17th July 2023

Reference MB230703

Planning Reference H/23/95031, issued by Eastleigh Borough Council, as a retrospective application for the retention of the erected double garage at the property.

Arbor-Eco Consultancy Tree Constraints Plan, Drawing Number MB230703-01-01 dated July 2023.

Fig 1: *Location of defunct cesspit.

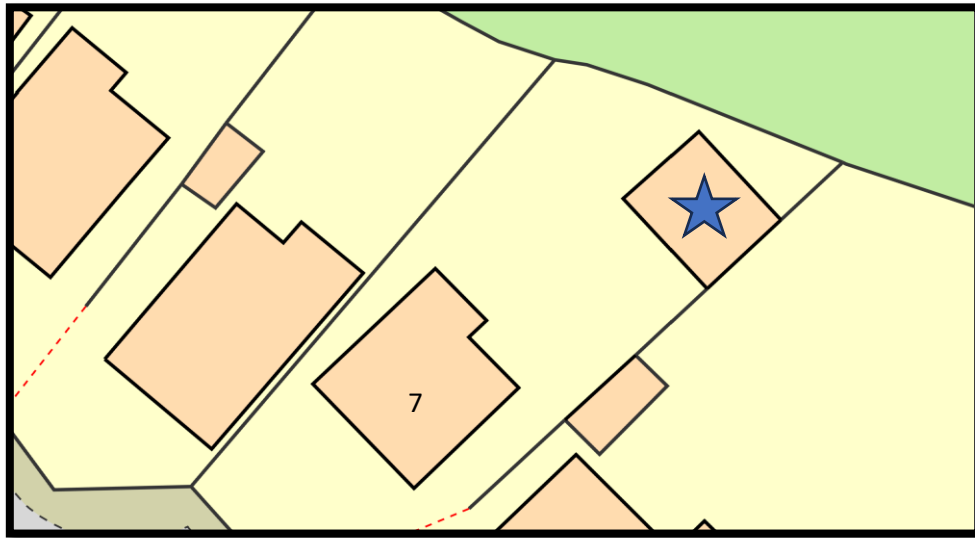
- I object to this application because it could have an unacceptable impact on the SINC due to disturbance and hydrology and on the trees. A 20 m buffer is normally required between a SINC boundary and any development. What is the actual distance between the rear of the building and the site boundary?

- Even if this qualified as permitted development, a building should not be allowed to be built right up against the SINC boundary.
- Does the building have any surface water drainage arrangements? I don't see any rain gutters on the site photos but I do see a raised drain cover on top of a pipe in the 2nd photo which also appears to show a large window at the rear of the garage. Why does the garage have such a large window to the rear? If it is to be retained and used at night, the window must be covered so that light does not shine out onto the SINC. There also appear to be two exterior lights on the front of the garage. This must not be kept on all night, but only as needed, with a motion detector for security purposes.

Prior to the construction of the garage block (for retention) a defunct cesspit existed and is shown on Plate 1 and on historical OS map on Fig 1.

In response to the ecological concerns raised it can be seen that a man-made structure was constructed within 20 m of the SINC. Indeed, the existing bungalow is within 20 m (along with a further 9 properties and most with garden buildings of varying design within 20 m of the SINC. Arbor-Eco Consultancy considers this objection a moot point based on historical fact and current evidence. The 20 m rule should apply to all properties that are adjacent to the SINC and not solely number 7.

Drawing Number MB230703-01	Rev A
--------------------------------------	-----------------

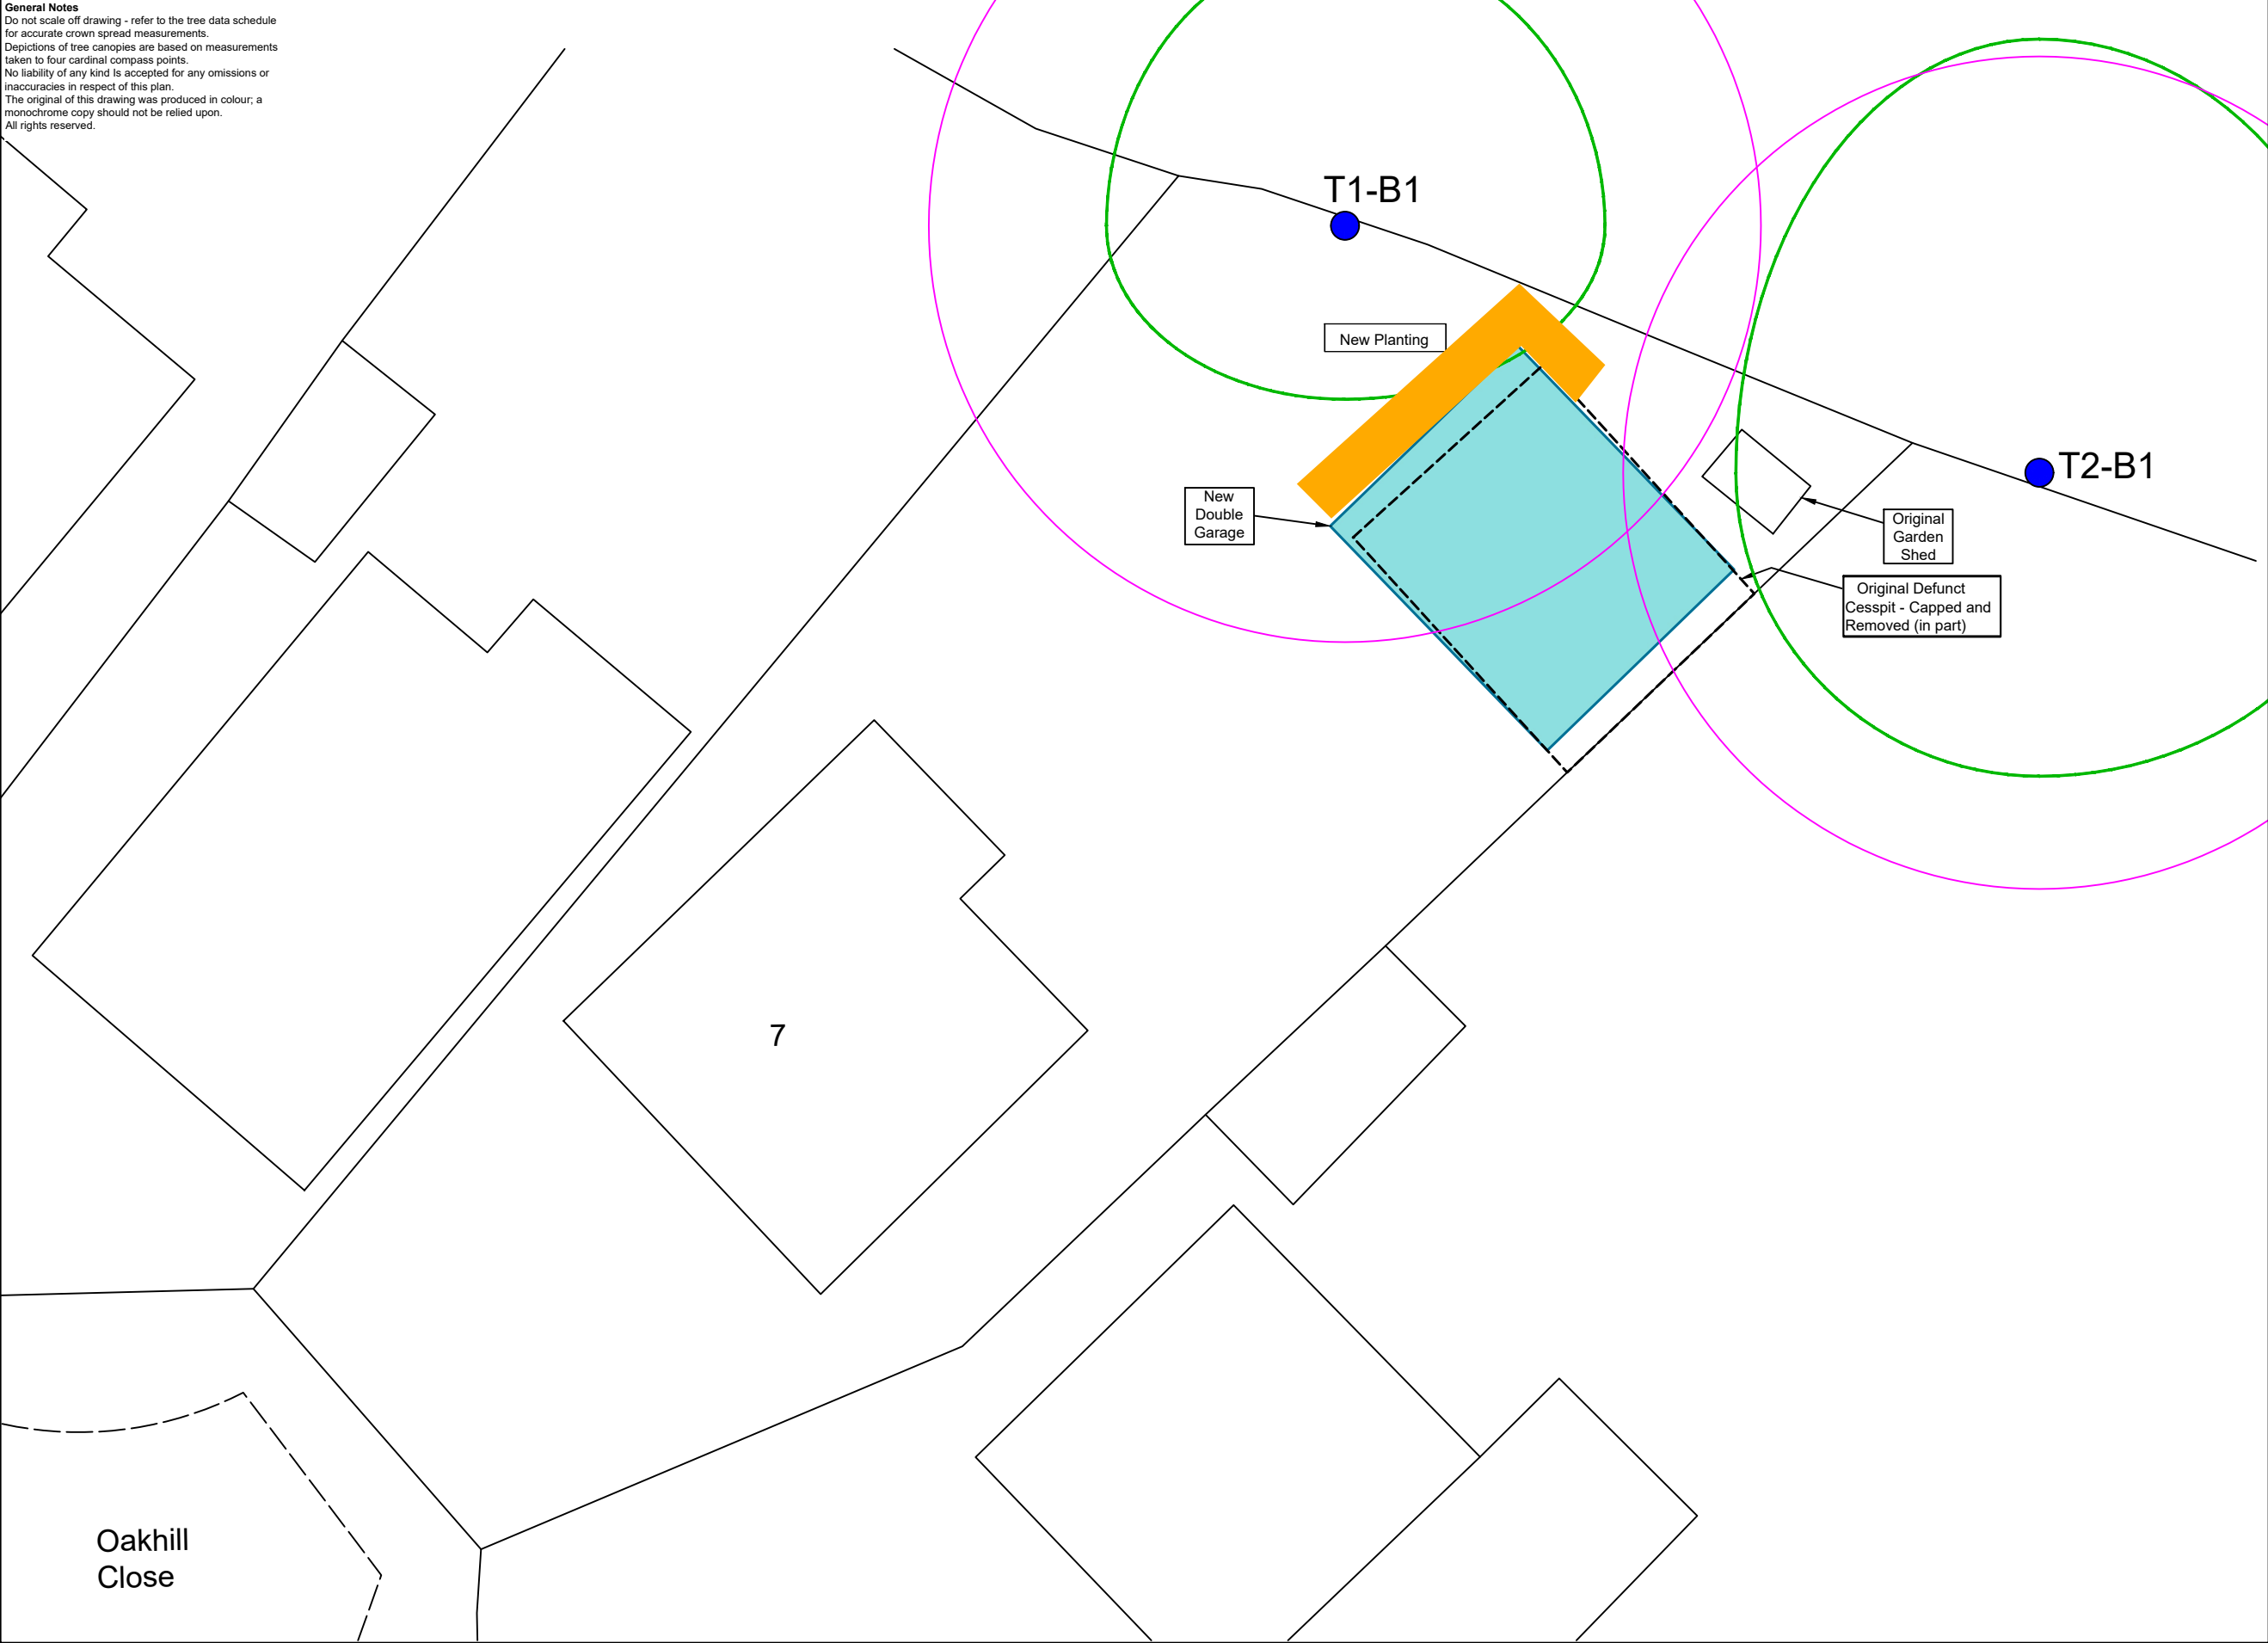
- There are two oak trees within potential influencing distance to the structure – one to the east and one to the west. These trees are subject to a Tree Preservation Order.

- The structure may be within the Root Protection Areas of these two trees and, thus, may have had a negative impact. However, without arboricultural information – tree survey and impact assessment - it is not possible to determine.
- Therefore, we raise a holding objection and request arboricultural information. In addition, we would like a method statement detailing any remedial work, if it is deemed that there has been a negative impact.

T1, as shown on Tree Constraints Drawing MB230703-01 indicates that the default RPA is within the influence of the constructed garage block.

T2, as shown on Tree Constraints Drawing MB230703-01 indicates that the default RPA is within the influence of the constructed garage block, however, the impact of the development is deemed to be insignificant due to a previous structure within the default RPA. This tree is an off-site tree at a distance so as not to be influenced by the development due to historical structures within the site.

In terms of providing assistance to the biodiversity of the site, the owner has already expressed a wish to plant herbs such as Lavender (*Lavandula angustifolia*), Rosemary (*Salvia rosmarinus*), Thyme (*Thymus vulgaris*), Sage (*Salvia officinalis*) and Oregano (*Origanum vulgare*). These are some of the best pollinators according to the RHS. These will be planted within the gardens space and in addition, a narrow section of land adjacent to the building will be utilised solely for pollinating plants as is shown on Tree Constraints Drawing MB230703-01, enclosed.

1. Using a tracked mini-digger, of no greater than 1.5 t in gross weight, shall remove between 75 mm and 150 mm of soil within the 10 m default radius of T1. This will include the removal of historical builder's debris and contaminated soil (in so much as bricks and concrete were observed).

2. The work will be graded in so much as 75 mm will be removed nearer to the stem and working in arcs towards the property to eventually remove 150 mm of soil and debris. This depth will only be exceeded on the agreement of the retained Arboricultural Consultant to further remove contaminated land if necessary.

3. The machine will operate from outside of the 10 m radius of T1 and only track within the 10 m radius in a straight line. No ground protection is deemed necessary as this has been a heavily utilised and compacted garden prior to Miss Knee occupying the residential property. This work shall be completed under the supervision of the retained Arboricultural Consultant.
